HISTORIC PRESERVATION BOARD MEETING CITY OF ST. PETE BEACH

Thursday, April 6, 2023
2:30 PM

c. Design Review Case No. 23005 - 108 21st Ave

**PLANNING & ZONING DIVISION
STAFF FINDINGS REPORT
TO THE
HISTORIC PRESERVATION BOARD**

BUILDING ELEVATION-NORTH
(FRONT ENTRY)

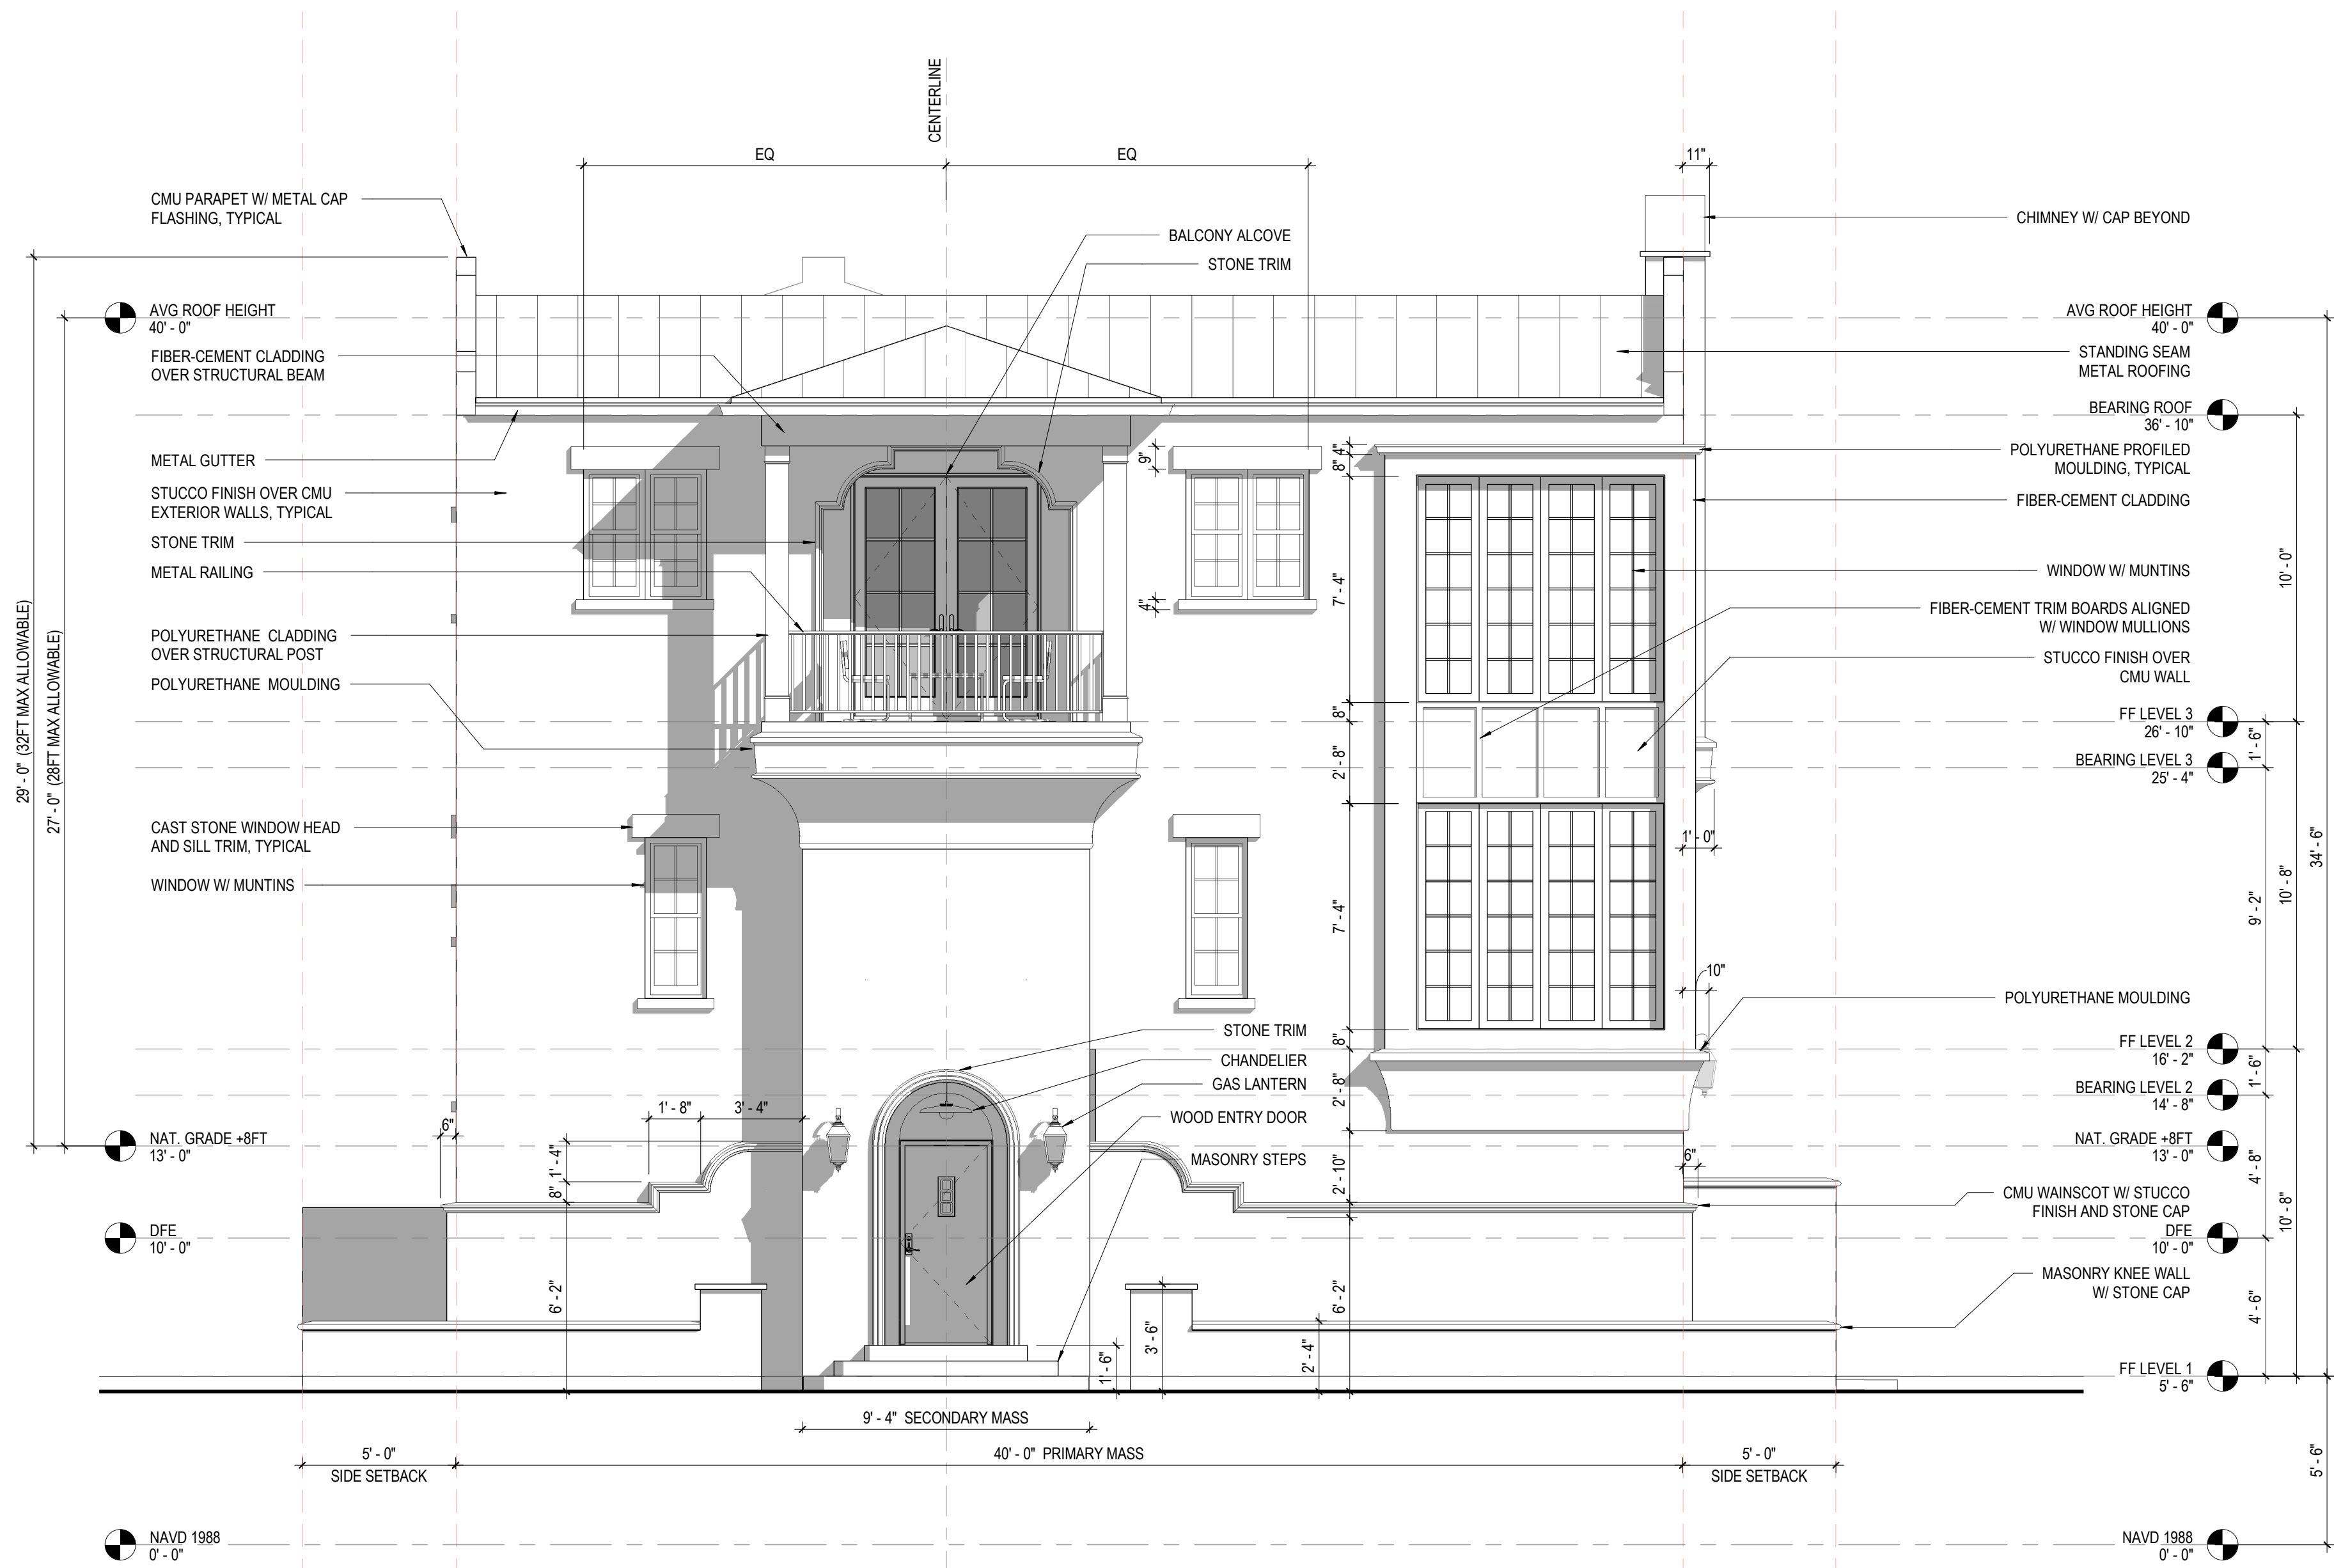
The city's architect opined that this standard was not fully met. The large window at the northwestern side of the structure, while providing visual interest to the façade, does not provide for equal visual volume at the centerline of the front door and places greater weight on the northwestern frontage of the structure.

The city's architect found this standard to be met, with the exception of the vertical visual consistency comment mentioned prior.

- 3) The city’s architect notes that a terracotta-style roof would be more compatible with the Mediterranean style than a standing seam as proposed.
- 4) The landscaping plan shall retain the layering of groundcovers and shrubs as shown on the current conceptual plan, and shall meet or exceed the total tree count, species and quality for both the lot as a whole and the 21st Ave frontage. However, Staff requests the Board approve the conceptual plan on the basis that the applicant shall adhere to the code standards for landscaping.
